VOLVO CAR SERVICE AND PARTS BUSINESS

Technical Journal

TITLE: Left engine pad click sound

| REF NO: | ISSUING DEPARTMENT: | | ARKET: |
|---------------------|-------------------------------|-------------|--------------|
| TJ 33442.9.1 | Technical Service | | s and Canada |

TJ Instruction VCC-514276-1

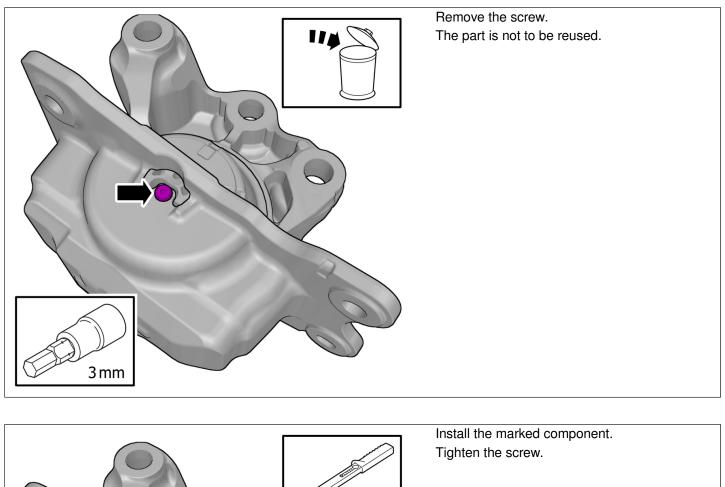
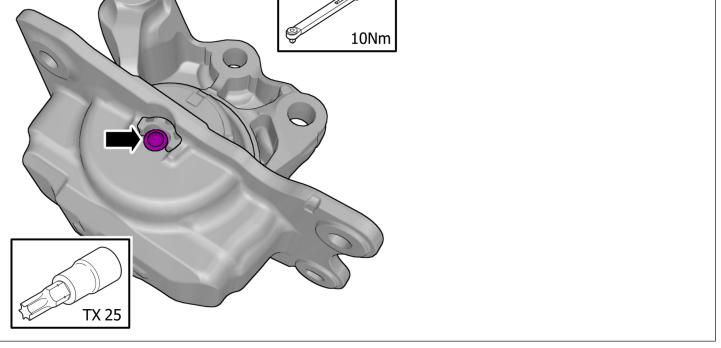
| | Note! Removal steps in this procedure may contain installation details. |
|-------|---|
| | Remove left-hand engine support insulator, refer to: |

Separate the engine pad and lubricate with graphite (see attachment), then follow instruction with new screw and washer. Torque 10 NM.
